GOLDFINCH

4711-4717 Aurora Ave N, Seattle WA 98103 | Project# 3029853-LU

Northwest Design Review Board / Recommendation Meeting / 16 September 2019

zone transition section

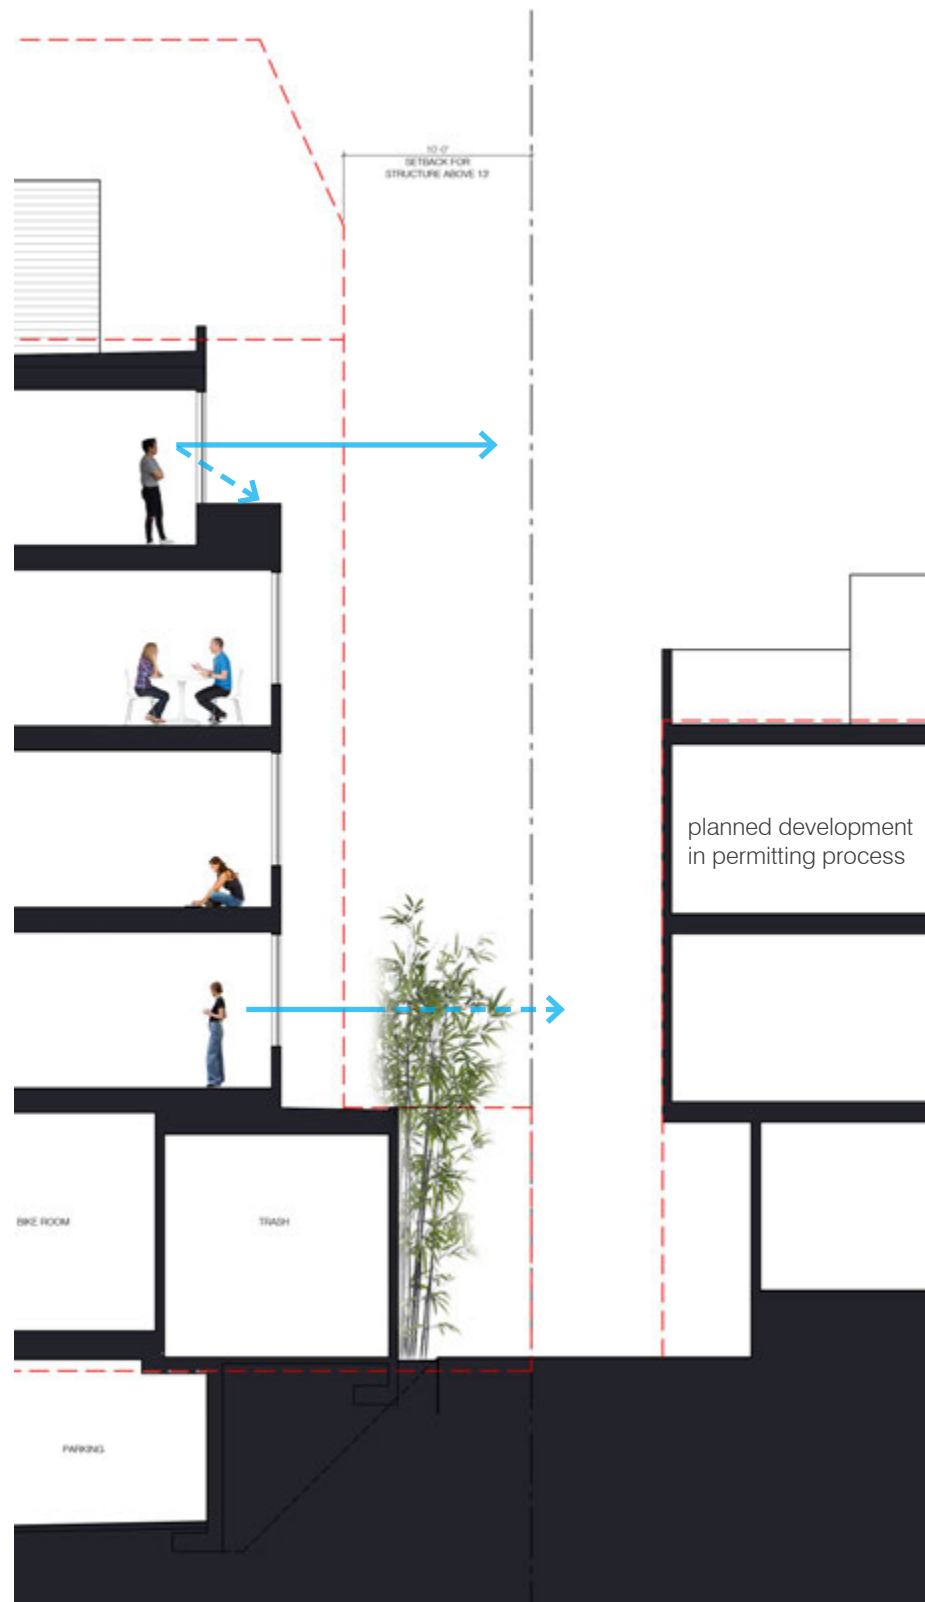
iii. There is a zone transition at the west edge of the site to the lower height and lower density neighborhood. The articulation and massing should respond to the transition to the lower height at that edge. (CS2-D, CS3-A, DC2-A)

Floors two to four are setback 13ft from the lot line which is three feet more than required. The top floor is set back an additional 4 feet, or 17 feet from the lot line. This massing articulation steps the top floor in response to the lower height and density of the LR1 zone to the west of the project. The fenestration at this level is articulated with accent panels between windows across the entire frontage. This level is read as an attic or penthouse, set back and differentiated from the body of the building below. The long window grouping then wraps around the corner and stitches into the vertical slot at the stair to further articulate the building mass.

articulation

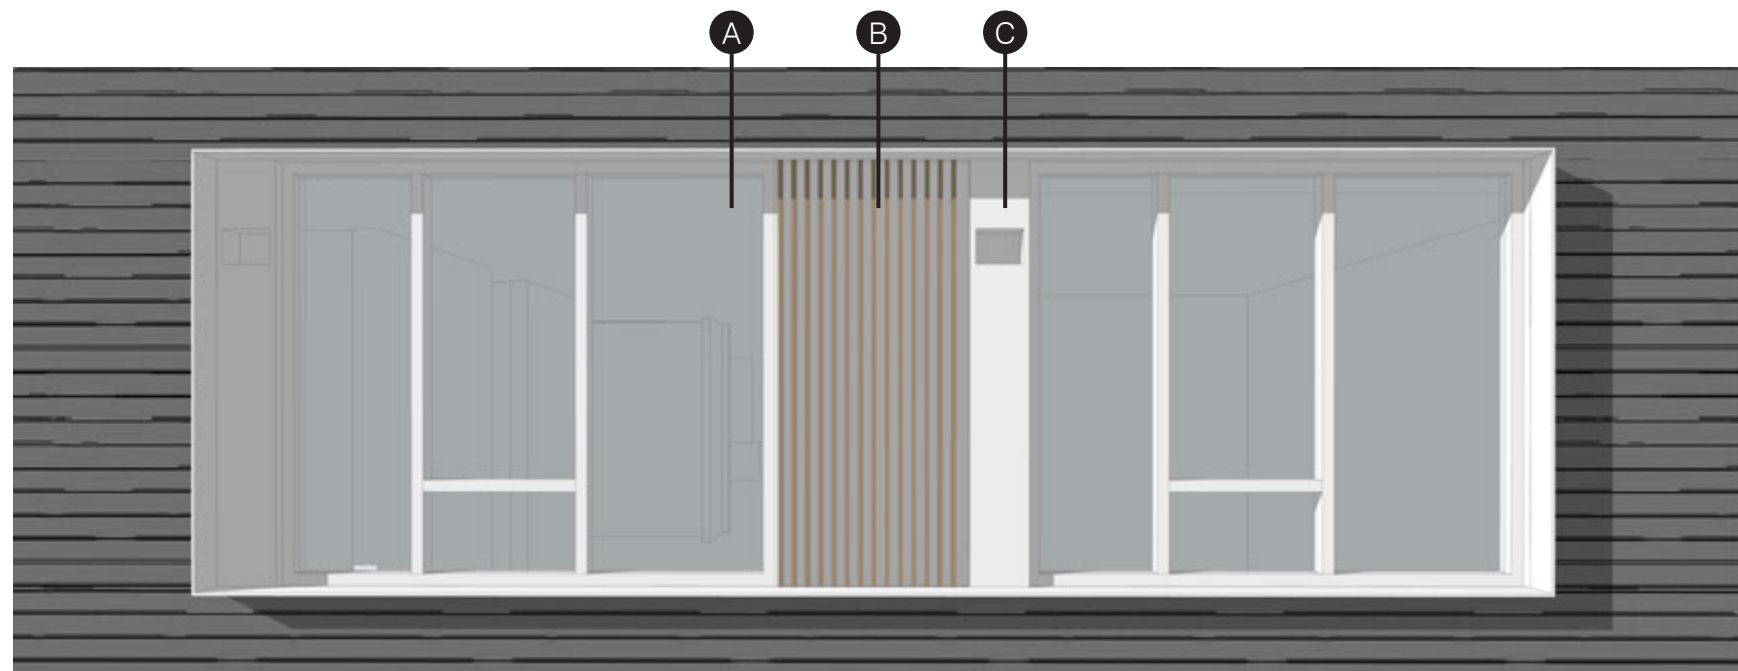
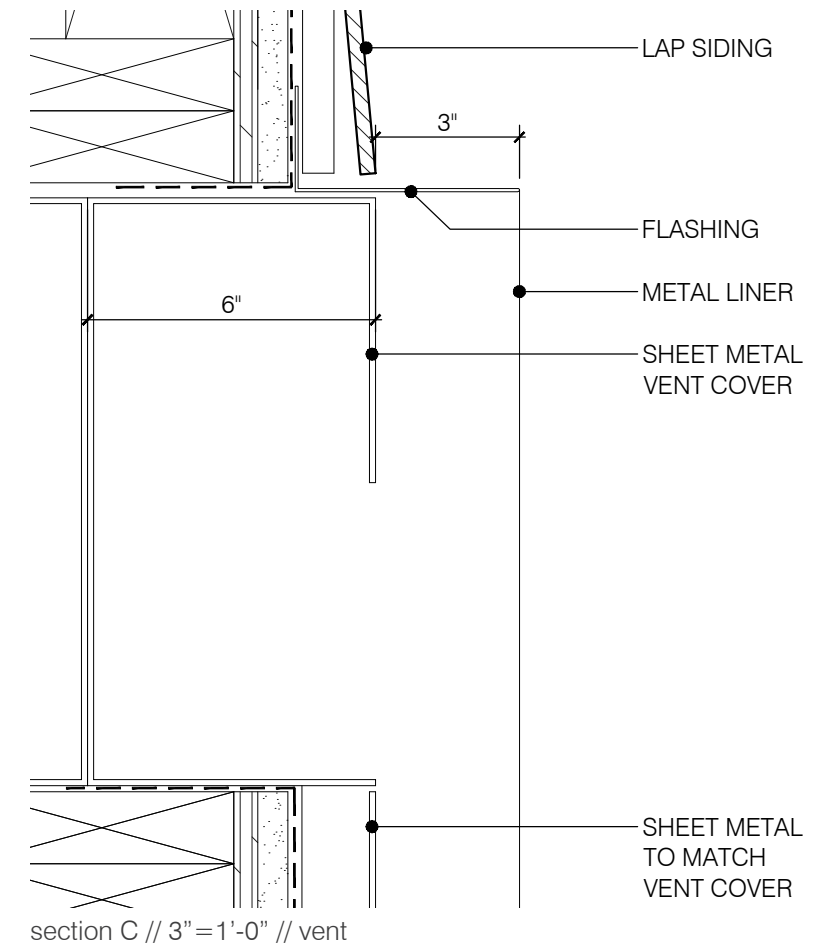
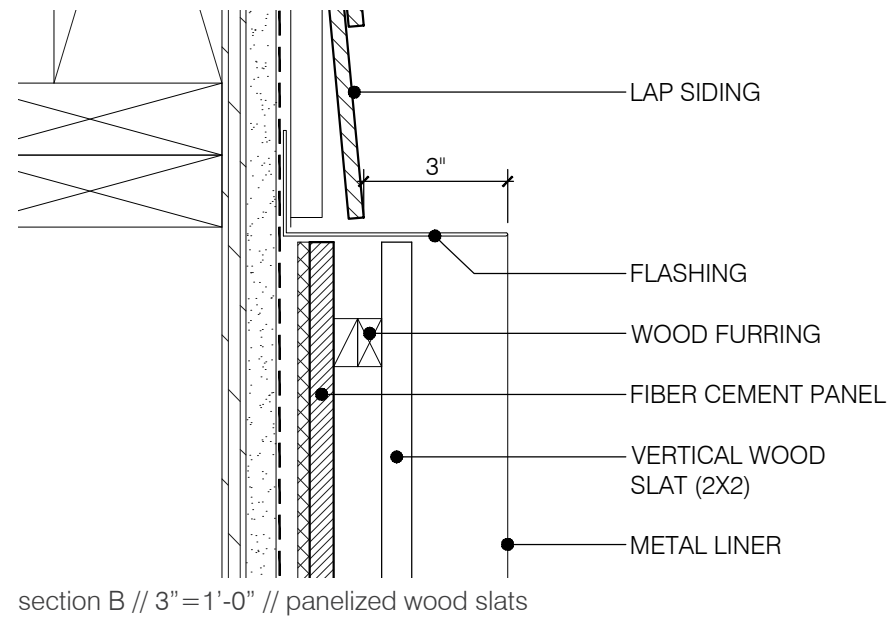
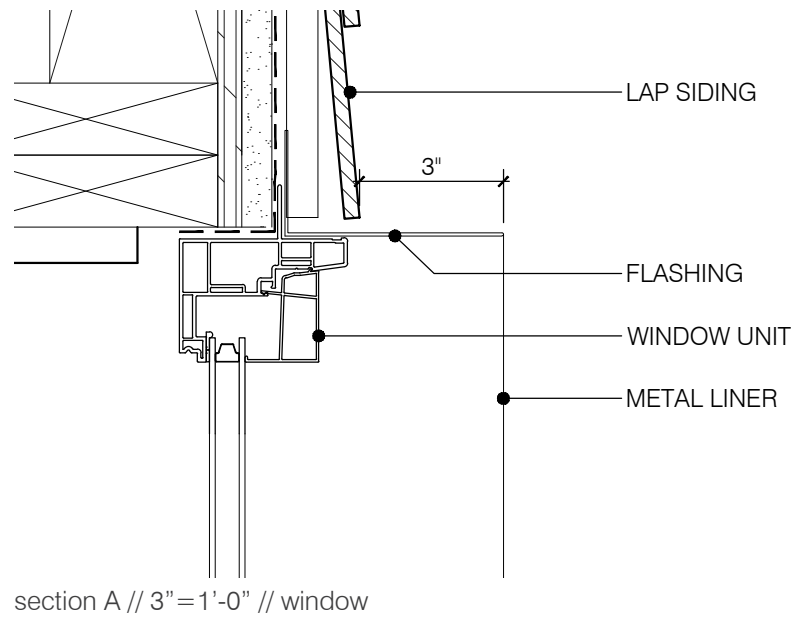
b. Façade articulation. The Board observed that the proposed design will need to respond to two different contexts: looking over busy Aurora Ave and one among single family residences on N 48th St.

i. Further development is needed to make the separate pieces of the building feel whole while still relating to the character of the two different streetscapes the building will face. (DC2)

ii. The Board noted there were good themes coming out of the exploration of façade articulation provided in the packet. For example, the “Offset” style of fenestration illustrated on page 46 of the packet has potential, but needs to better tie in with the ground floor. The Board noted this façade pattern spoke to movement, which was great for the context of Aurora. However, the residential character of N. 48th St should be reflected on the north elevation. The Board gave guidance to design the building to read differently on its two street facing facades, using materials and other details to unify the overall design concept. (DC2, DC4-A)

iii. The Board suggested that windows with depth, modulation, and articulation would help to express the residential use and to relate the overall design better to the context of each street frontage. (CD2, DC2)

The façade has been articulated to unify the building while relating to the character of the two different streetscapes. Four-inch horizontal lap siding is proposed from the ground up to create a strong building figure. Throughout the figure, large scale modulation is created by carving into the body (see Massing above) Fenestration scale and proportion have been carefully studied to better respond to the residential scale to the west. The window sills have been raised to provide visual privacy and allow furnishings on the outside wall. Groupings of windows and infill panels within projecting trim allow grouping widths to be scaled in response to the conditions on each side of the project. Lap siding and wood batten panels within the groupings provide a domestic feel.

The “offset” fenestration pattern has been further developed to achieve the balance between openings and solid façade. Variations in width, stagger, and extent are introduced to provide a subtle differentiation between the west and east façades, and a more overt differentiation of the building step on the west side.

The grouping of window, infill panel, and venting are detailed to create façade depth and texture.
